Submission: Carpentaria pilot EPA referral

Objection: Carpentaria pilot Environmental Management Plan EP187

REVIEW OF THE HYDROGEOLOGICAL AND HYDROLOGICAL IMPACT ASSESSMENT IN THE ENVIRONMENTAL MANAGEMENT PLAN FOR THE CARPENTARIA PILOT PROJECT

Comments on groundwater risk assessment for Carpentaria Pilot Project Environmental Management Plan: Imperial Oil & Gas EP187

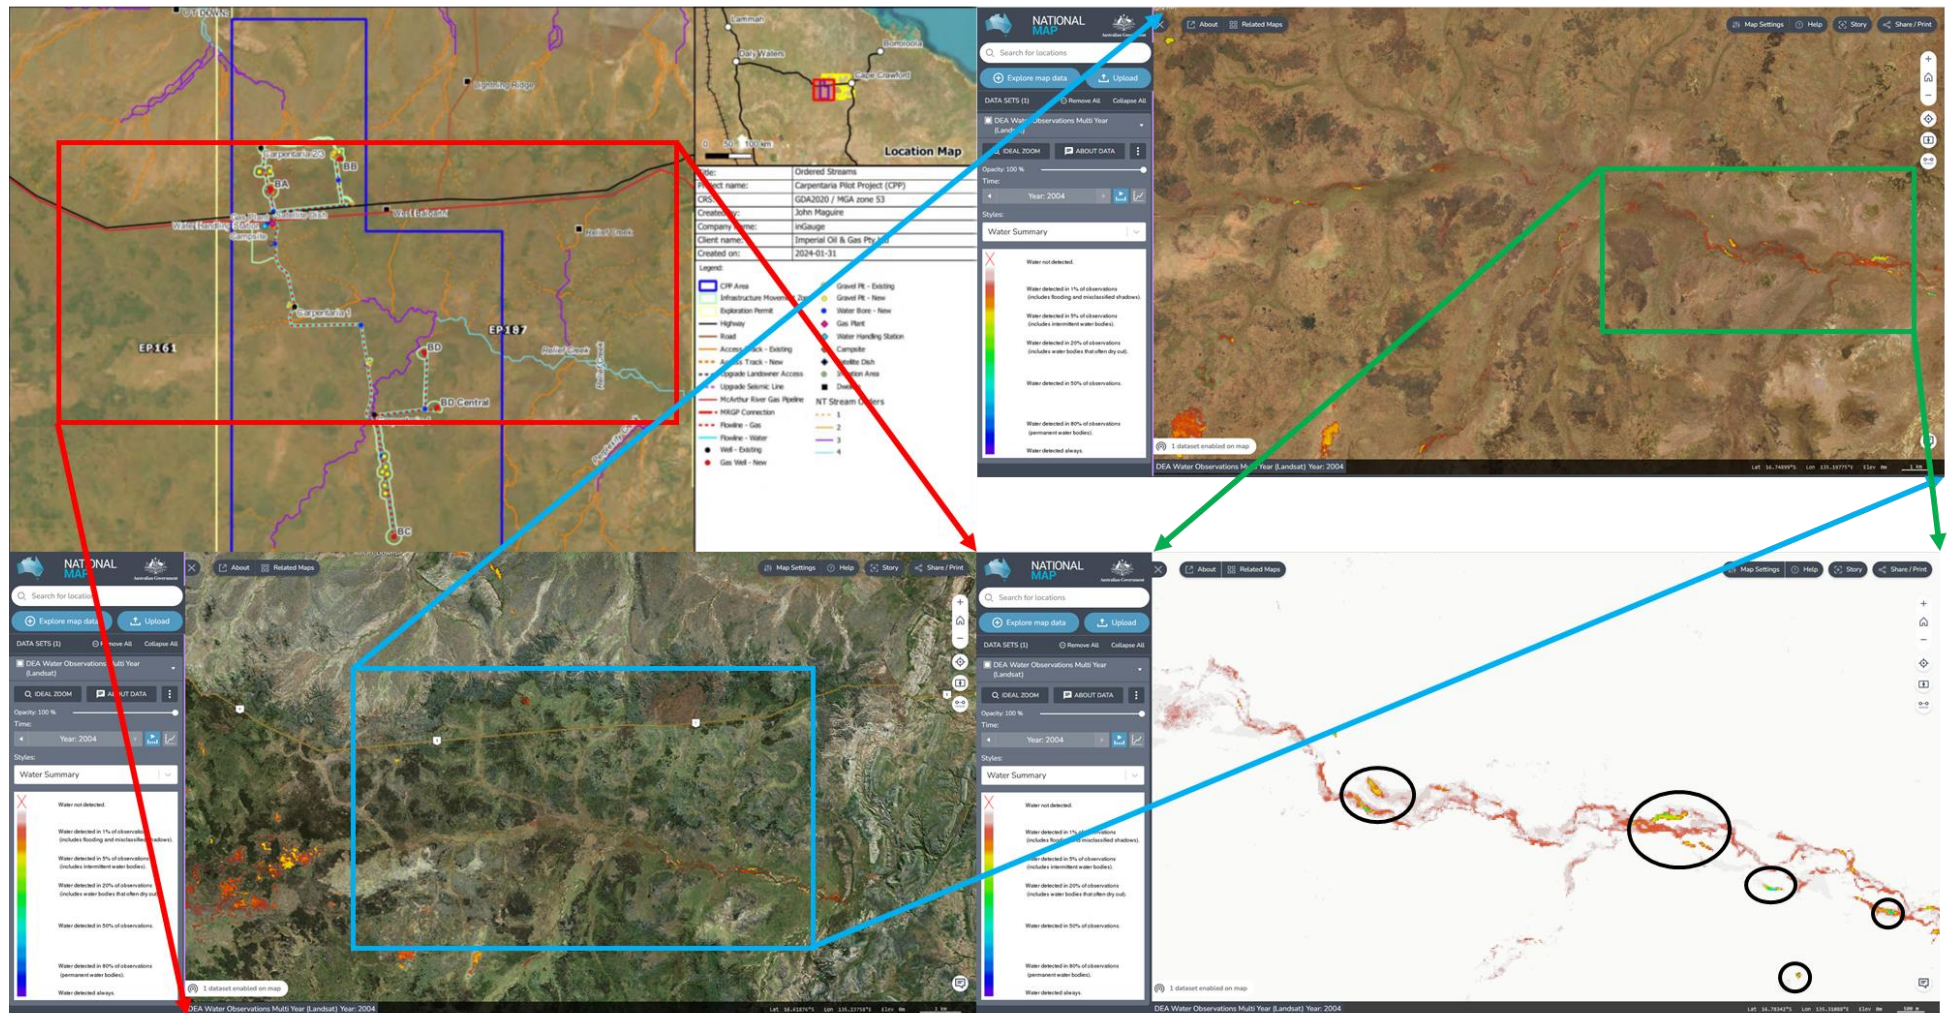
Comment – There are a lot of waterholes east of “Carpentaria 1’ along the Relief Creekline. No information is provided on these waterholes and if or which aquifer they are connected to. Are they permanent and are they groundwater dependant? See Figure 1 above.
